**Assessment of Hydrogeologic Conditions and  
Need for Long-Term Groundwater Monitoring  
at the Former Durita Uranium Mill, Naturita, Colorado**

**Executive Summary**

Gene Peters and Randall Fedors

Figure 7. Topographic Map of Durita Site Showing Monitoring Wells. Modification of Downloaded File Obtained from Topozone™ on 07/17/2006.

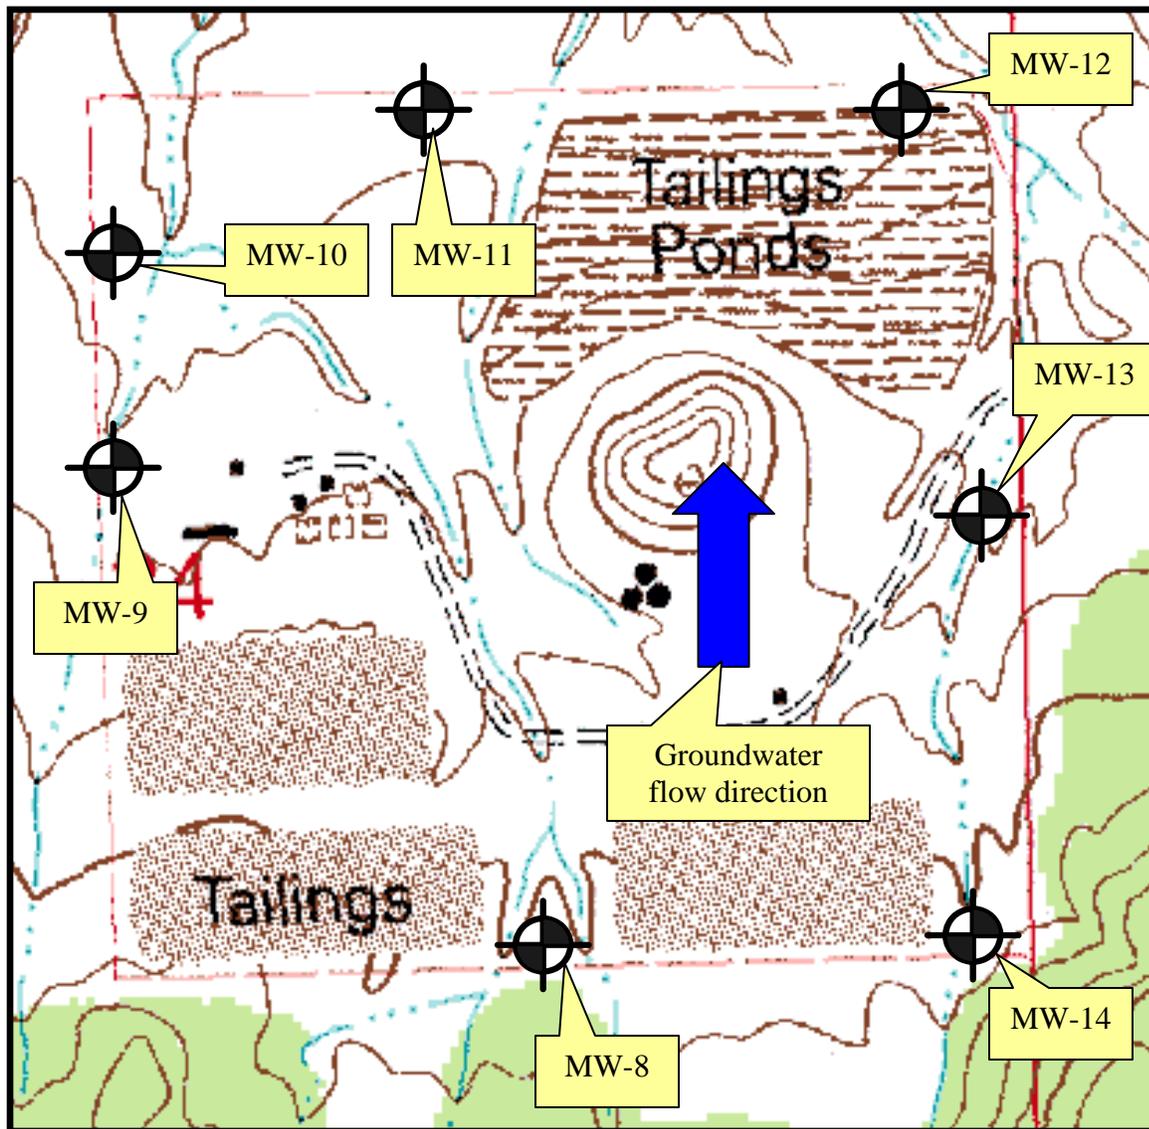
The gradient of the water table is northward towards Dry Creek, but is ill-constrained because it is only defined by seven wells installed along the property boundaries. The seven boreholes outlining the permit area (Figure 7) were drilled into the uppermost aquifer, cased, and screened for monitoring purposes. The monitoring wells are labeled MW-8 through MW-14. The screened intervals intersect the sand layers in the lower portion of the Mancos Formation. Wells MW-1 through 7, mentioned in Fox (1982), were completed during leaching operations in the late 1970s. These wells, however, were improperly completed; thus no data were reported in the available documents.

Of the seven wells monitoring wells constructed in the early 1990s, three are designated as downgradient monitoring wells (MW-10, -11, and -12), two are cross-gradient wells (MW-9, -13), and proximal to sources, and two are upgradient background monitoring wells along the southern Site boundary (MW-8, -14).

**Figure 8. Potentiometric Heads for Upstream Boreholes From Two Data Sources, Hecla (1998) and Studios Solutions (1994)**

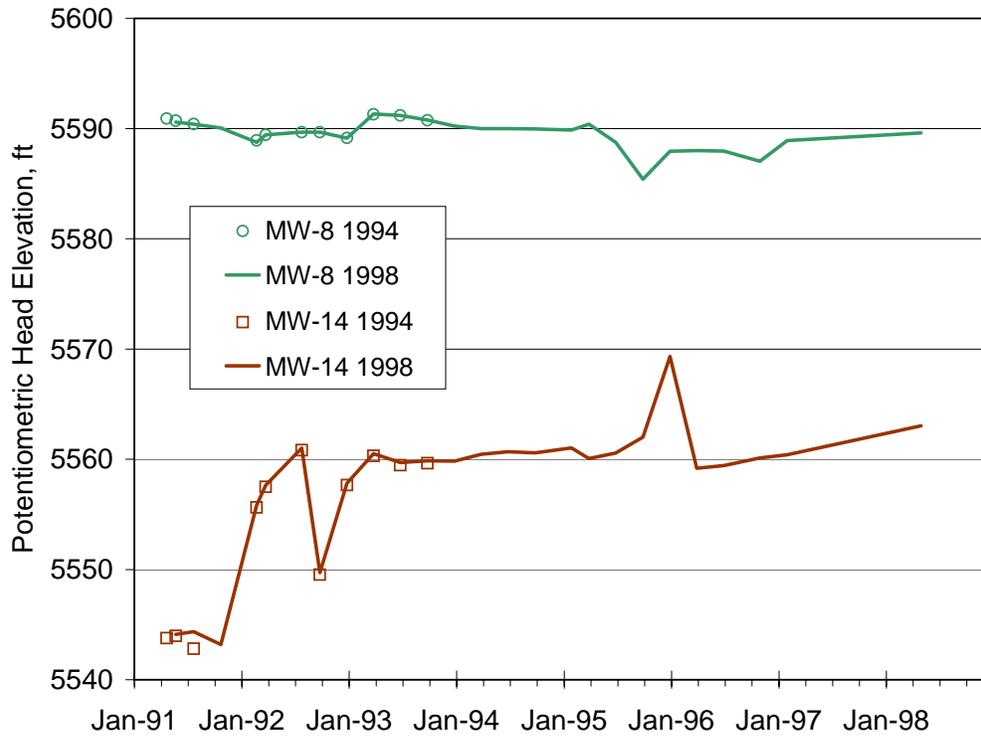
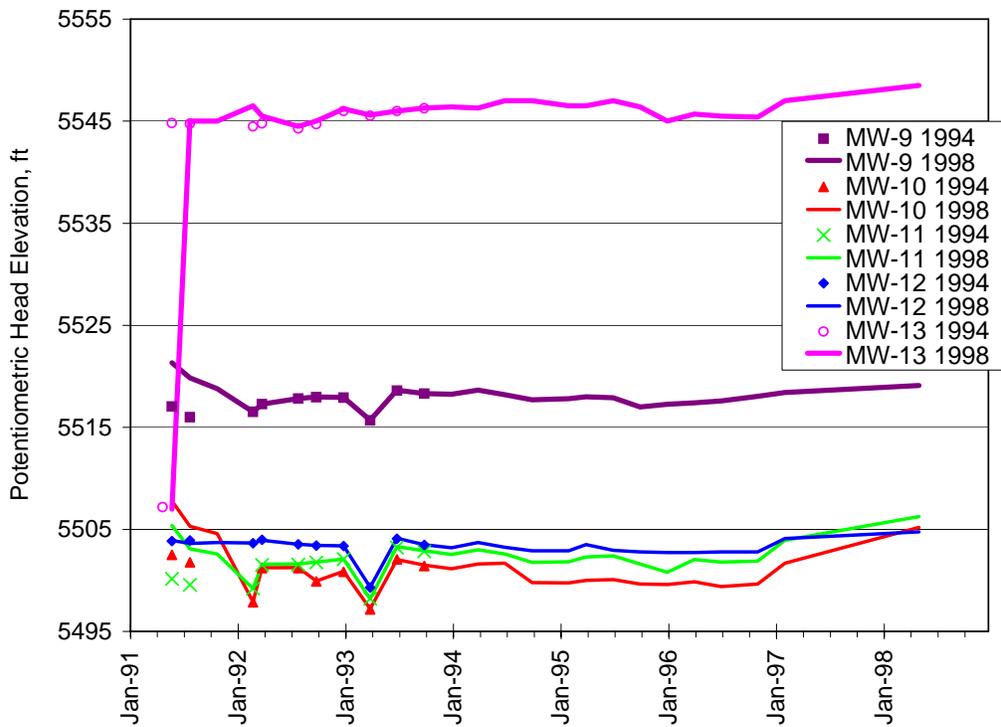
Water levels during the reclamation period, 1992 and 1993, are highly erratic. A prominent downward spike occurred in six of the eight wells late in 1992 (Figures 8 and 9).

The implication is that ground surface activities at the site impacted the water levels. One hypothesis, if preferential flow pathways are presumed to exist, is that re-grading or diversion channel development may have temporarily clogged the flow pathways. Other explanations may be just as reasonably postulated; regardless, it is clear that ground water levels were affected by surface reclamation activities.

**Figure 10. Smoothed Quarterly Precipitation Overlaid on Potentiometric Head Data for Upstream Wells**

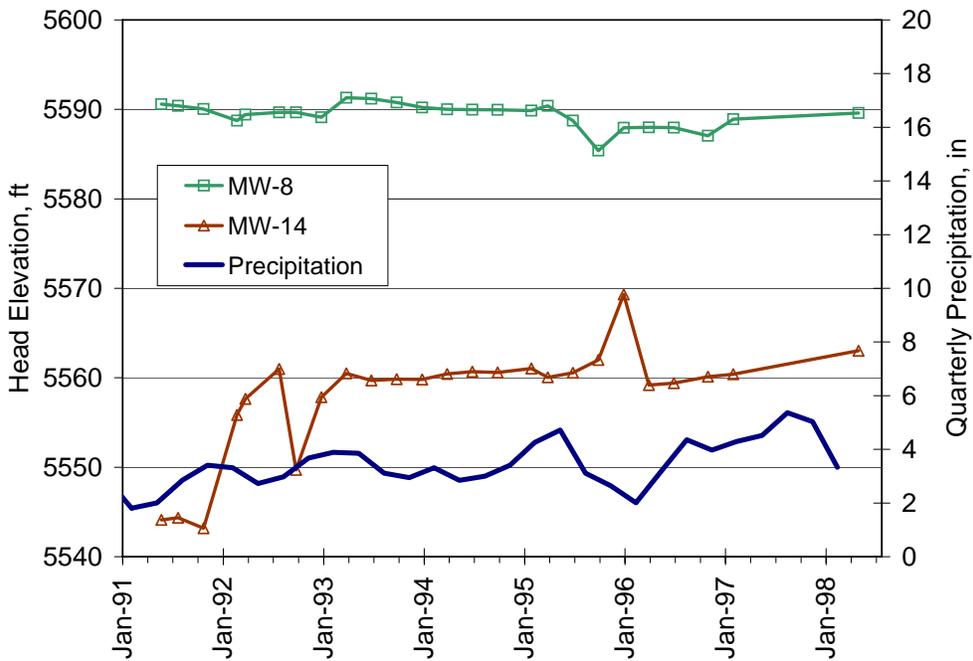
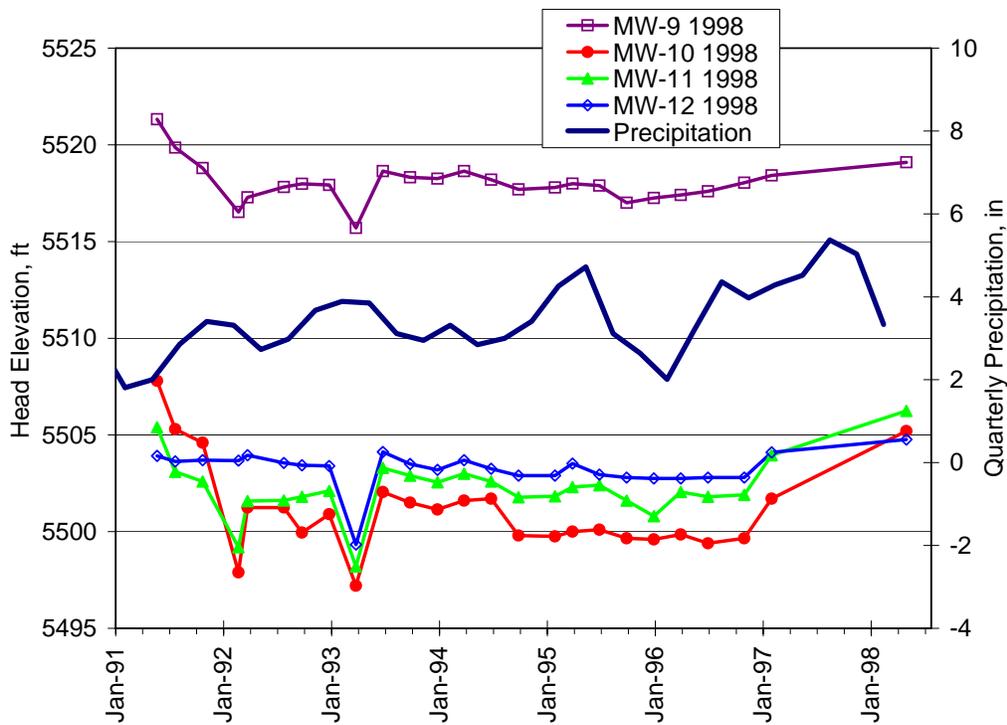
Temporal variations caused by climate stresses are evident when precipitation patterns are overlaid on the water level data (Figure 10 and 11). Two prominent observations are evident. First, a seasonal precipitation pattern is tracked by the water levels, particularly the downgradient (MW-10, MW-11, MW-12) and cross-gradient wells (MW-9 and MW-13). There is a significant dampening of the precipitation signal, and a slight delay in the propagation of the signal. The second prominent observation is that all the wells show an increase in water levels corresponding to the wetter years of 1996 and 1997. The aquifer response to the increased precipitation varies across the site from +1 to +5.5 ft from Nov 1996 to Jan 1998. Note that this period only has three measurements, so seasonal signals are lost. The spatial variation in the seasonal pattern supports a local source for the recharge, rather than an upslope recharge where the sand units intersect the ground surface (related to the synclinal structure). For example, MW-9 and MW-10 are closely spaced with MW-9 upgradient from MW-10. These two wells show the largest and smallest increases over the 1996 to 1998 period; MW-9 increased by 1.0 ft and MW-10 increased by 5.5 ft.
